17. Structural Addendum #1 (ADD-S01):

ADDENDUM

ADD-S01

PROJECT: NCDSB Elementary School
CLIENT: Whiteline Architects Inc.
GENERAL CONTRACTOR: TBD
TRADE CONTRACTOR: TBD
DATE: June 23, 2026
AUTHOR: Trevor Arsenault

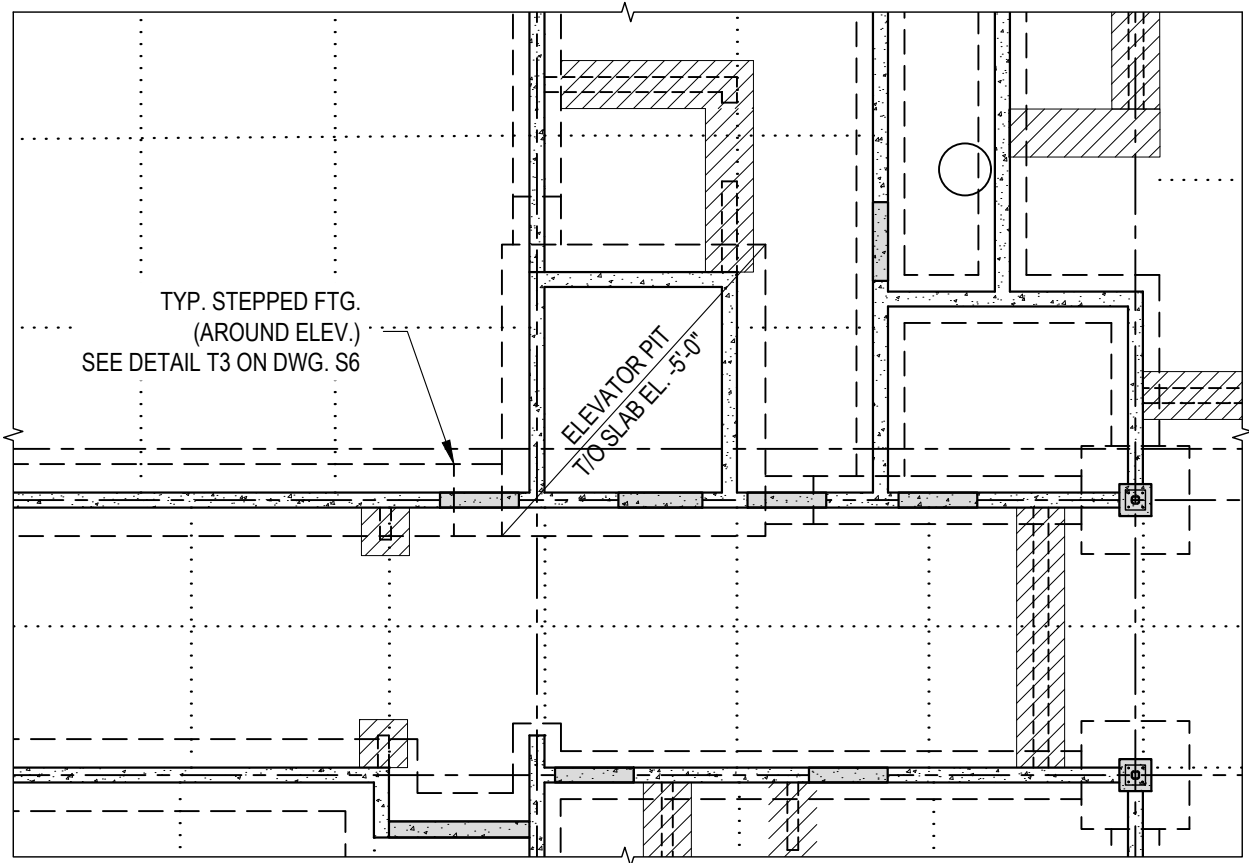
The structural drawings and the specifications note Seismic restraints for Mechanical and Electrical elements; however, the M&E drawings do not have any notes indicating this. Please confirm seismic restraints must be considered, designed, and allowed for by all Mechanical and Electrical contractors, as required.

Please provide the dead load to be used for roof joist design

Yes this is required. Refer to SSK1 for updated Design Loads

Refer to SSK1 for updated design loads

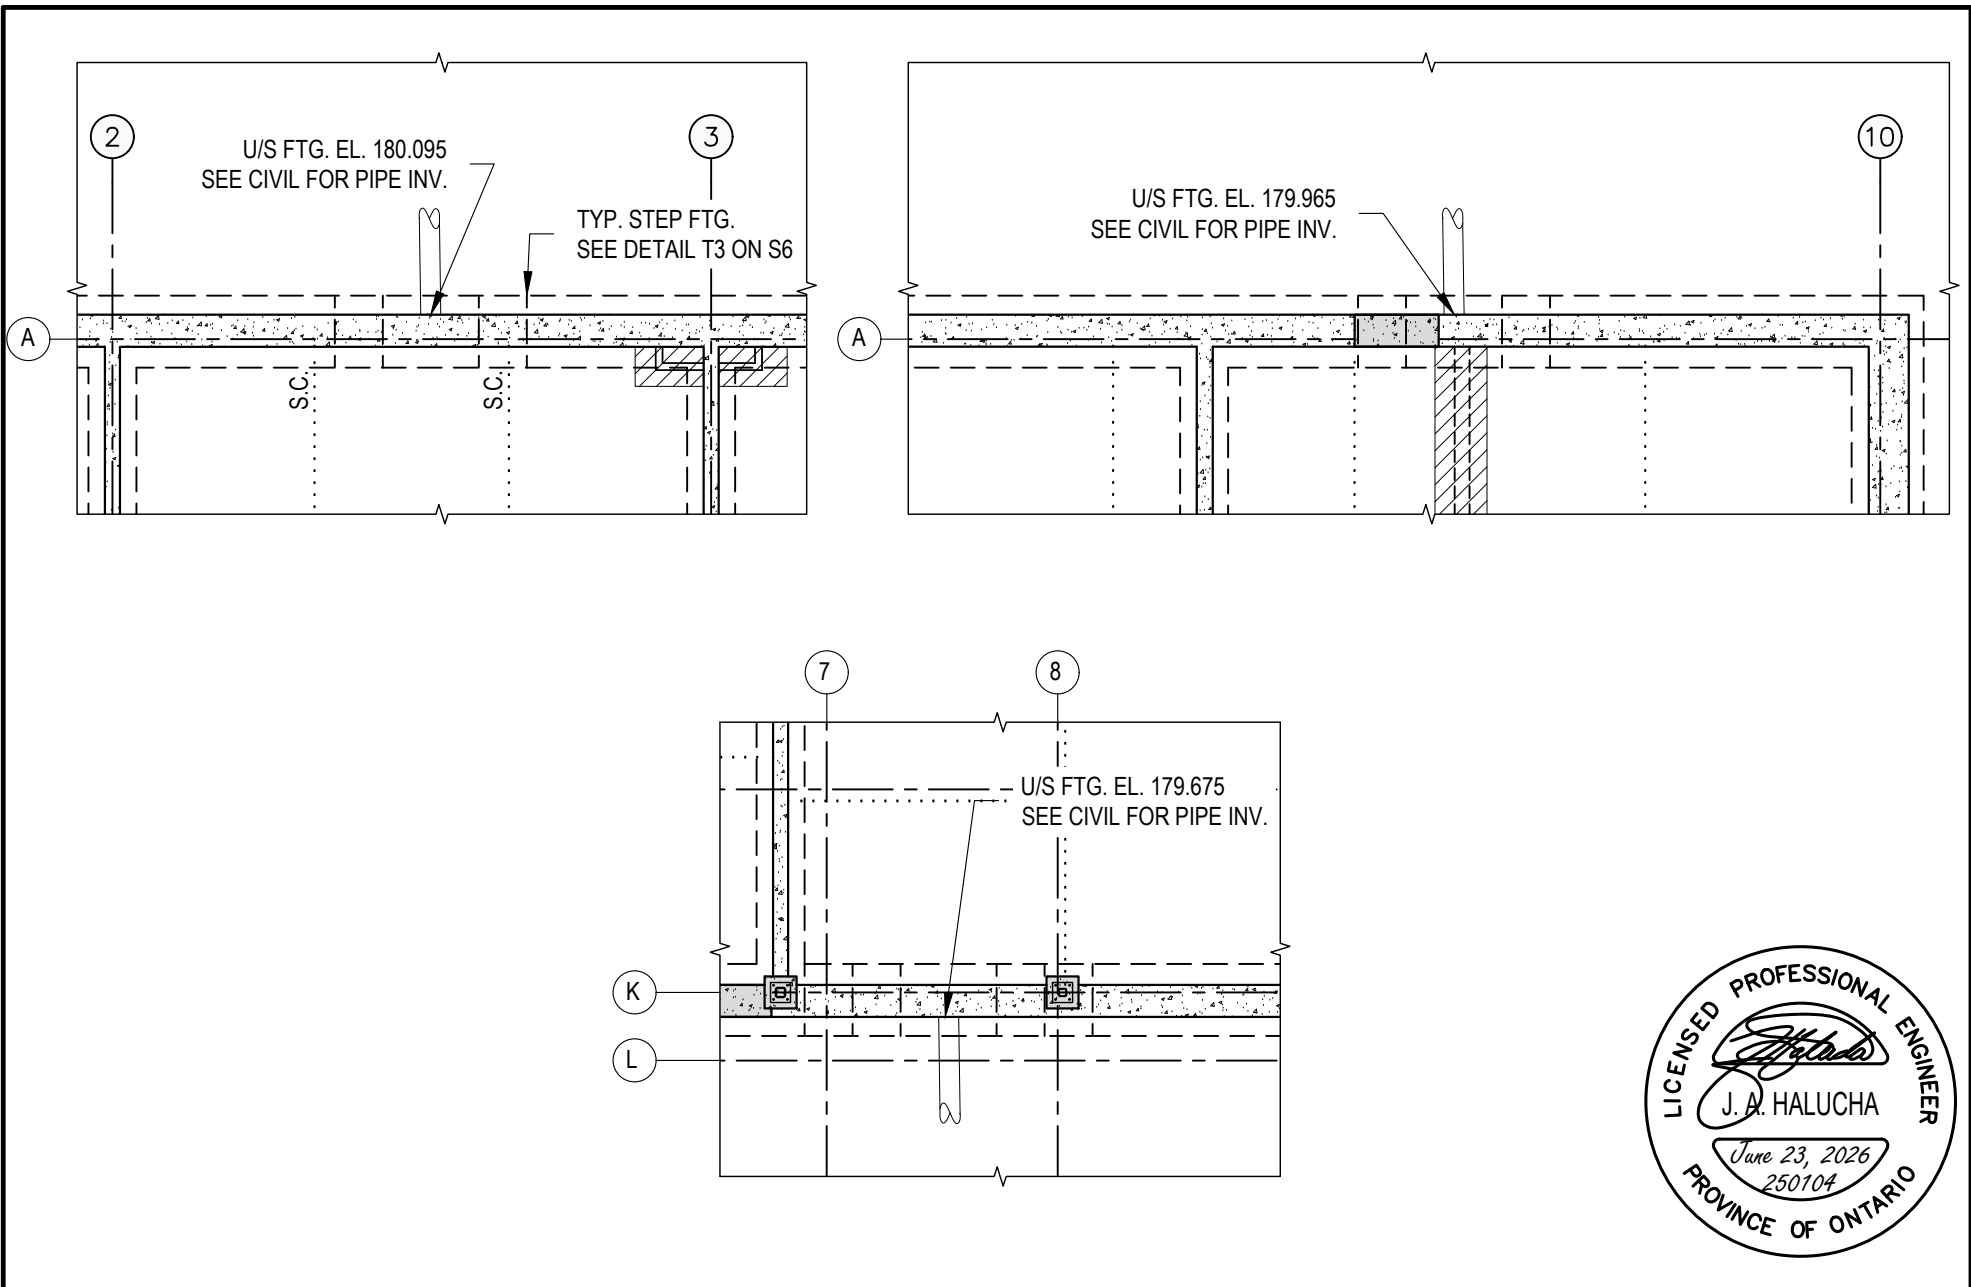
Are there any step footings required around the elevator pit?

Refer to drawing SSK2

DWG
SSK4

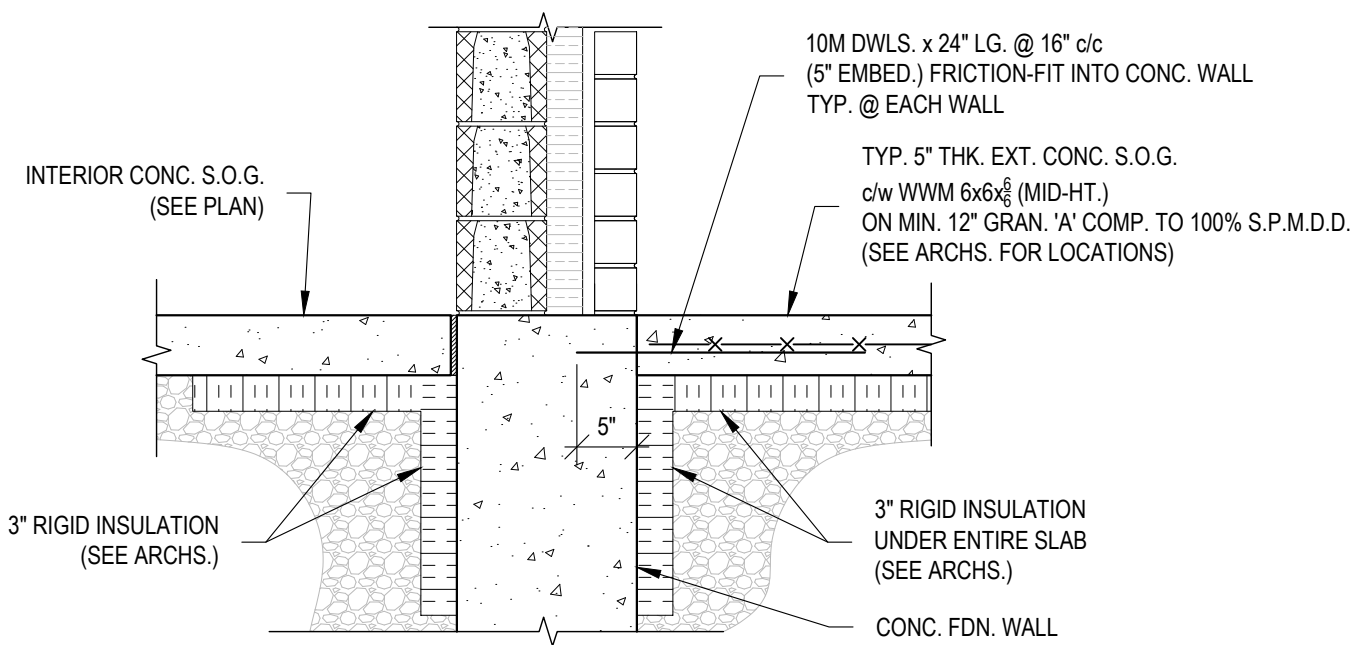
Please specify if special deflection is required for joists supporting the curtain divider at the Gym. If yes please provide the deflection

Maximum OWSJ deflection = $L/480$. Refer to SSK4.

DWG
SSK6

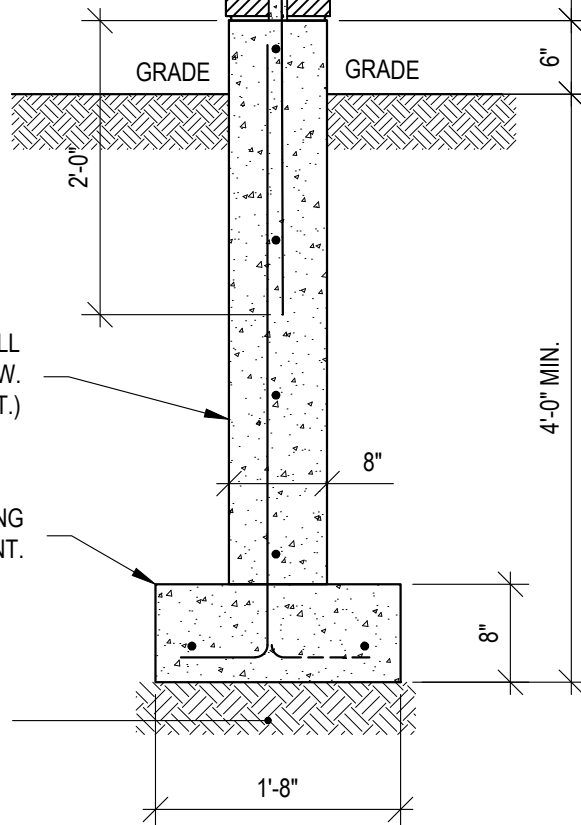
Kindergarten Play area masonry fence section on A1-2 shows a new fnd wall and footings as per structural, Nothing shown on structural, please clarify.

Refer to SSK6 for typical masonry fence foundation detail
